BRUNSWICK STEAM ELECTRIC PLANT, UNIT NO. 2
DOCKET NO. 50-324/LICENSE NO. DPR-62
ASME CODE RELIEF REQUEST - SERVICE WATER

Diesel Generator
Service Water
Relief Request

SYSTEM: Service Water (Supply Line to Diesel Generator No. 4)

Component: The 8" X 6" reducer on line 2-SW-234-6-157 just downstream on inlet supply valves 1(2)-SW-V213.

ATTACHMENT 1
RELIEF REQUEST NO.

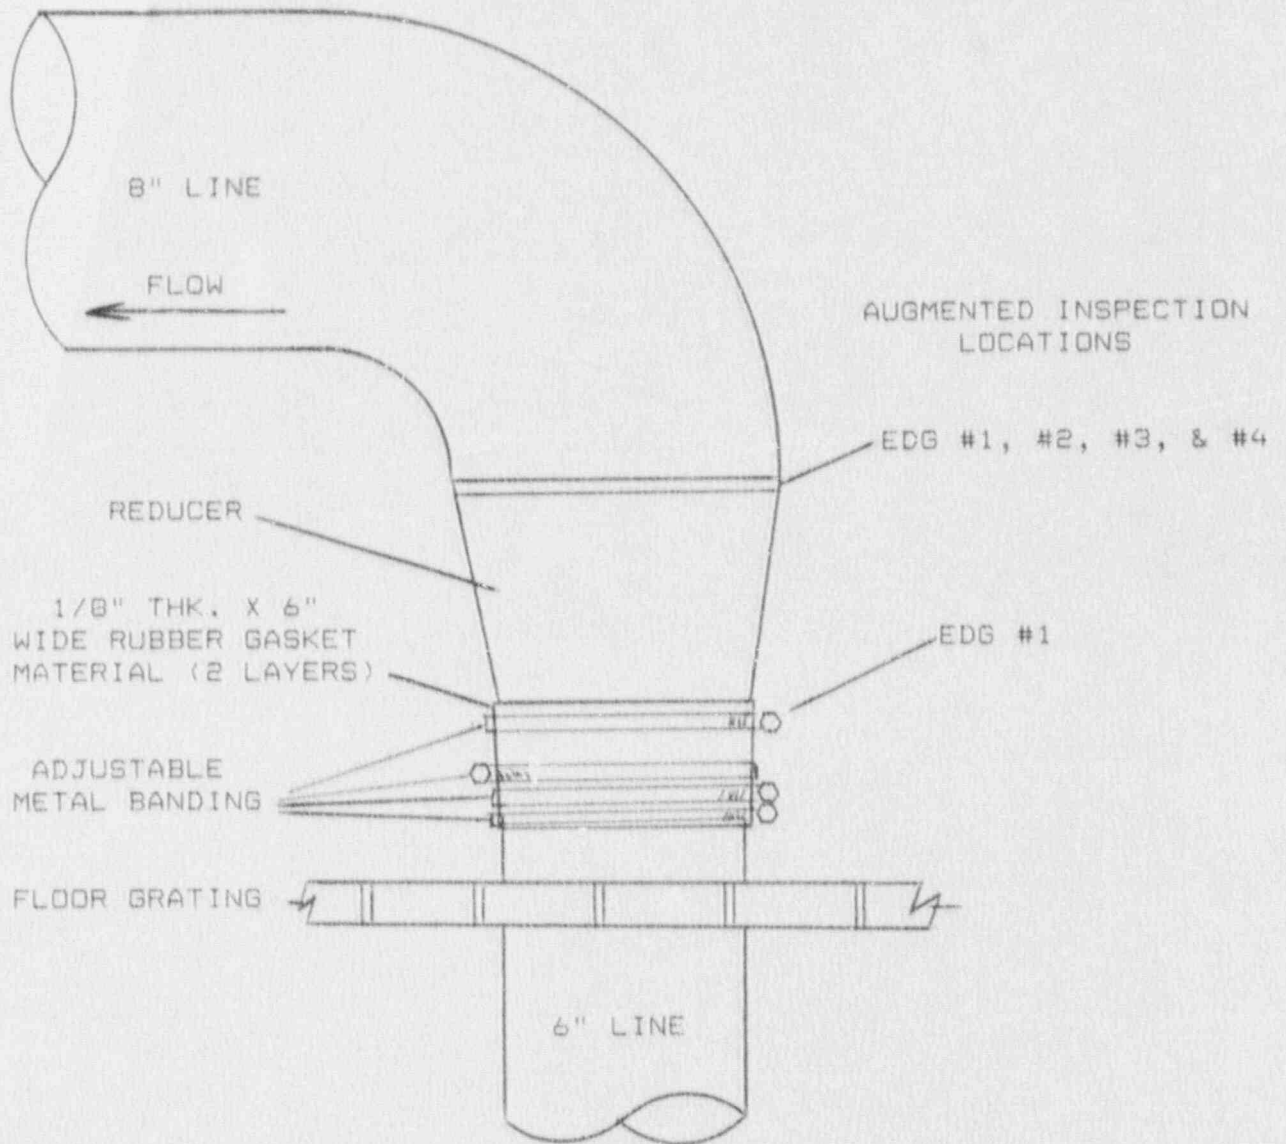
RELIEF REQUIRED: This request is being written to allow a temporary non-code repair of a through-wall leak on the referenced line. The through-wall leak was identified on the Service Water Supply Line (2-SW-234-6-157) to Diesel Generator No. 4 Jacket Water Cooler. The leak was discovered on December 13, 1990, at which time a Maintenance Work Request for the temporary repair of the through-wall leak was initiated and Tracking LCO T1-09-2456 generated in accordance with BSEP Procedure OI-4. The leak is located on the reducer referenced above in the "Component" section at the bottom weld no. FW-B80B as identified on FP 9527-22356, Drawing No. 2-SW-IS040. The through-wall leak is characterized as a hole approximately .25" diameter. Based on past experience, it is believed that the through-wall failure was caused by corrosion in an area exposed to the salt water through a flaw in the cement lining. A temporary repair consisting of rubber gasket material secured by mechanical clamps has been installed to prevent further leakage. The soft rubber patch represents a non-code temporary repair to be justified by this relief request. Refer to Attachment 1 for a diagram of that repair.

- SKETCH OF EMERGENCY DIESEL GENERATOR NO. 4 JACKET WATER COOLER INLET PIPING SHOWING 8" X 6" REDUCER AFFECTED BY REFERENCED THROUGH WALL LEAK (NOTE SOFT RUBBER PATCH).
- THIS SKETCH ALSO SHOWS THE LOCATIONS OF 7 SUPPLEMENTAL UTs PERFORMED IN ORDER TO INSURE COMPLIANCE WITH GENERIC LETTER 90-05.

9. Schedule implementation of permanent code repair - A permanent repair shall be implemented by the end of the next scheduled Unit 2 outage, now scheduled for April 1991. The repair will be made before that time if the 3 month UT/RT finds that it is necessary. The permanent code repair will consist of replacing the 8" X 6" reducer and the spool piece directly beneath it.

NDE DRAWING ATTACHMENT

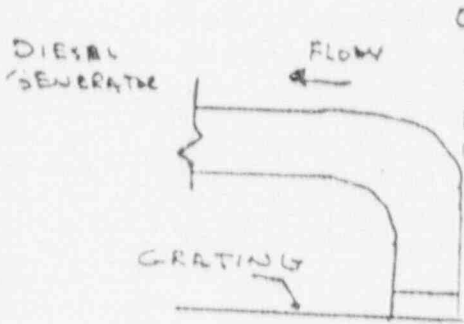
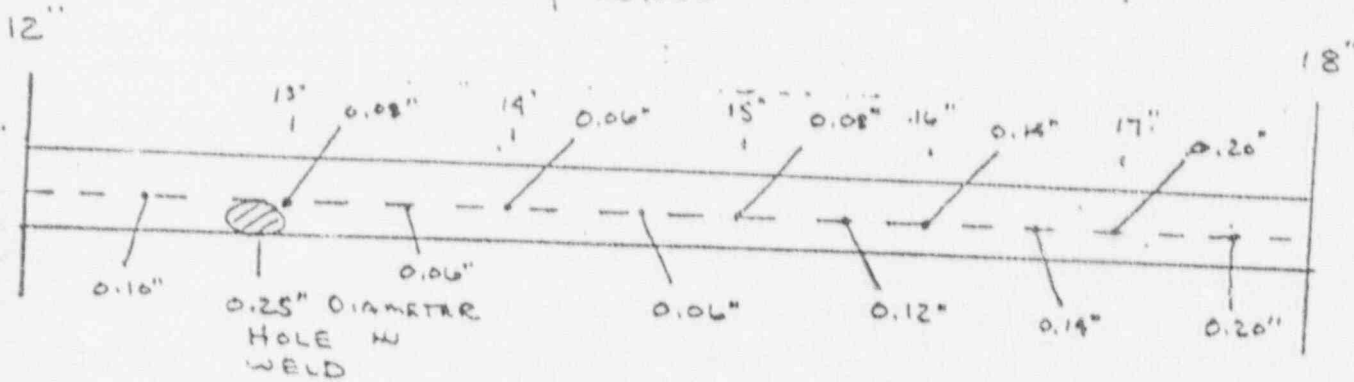
1. Document the character of the flaw cited - An Ultrasonic (UT) Non-Destructive Examination (NDE) was conducted on December 13, 1990. The actual through wall leak is characterized as a .25" hole with localized wall thinning adjacent to it along a section approximately 4 1/2" included as an attachment to this relief request (See Attachment 2).
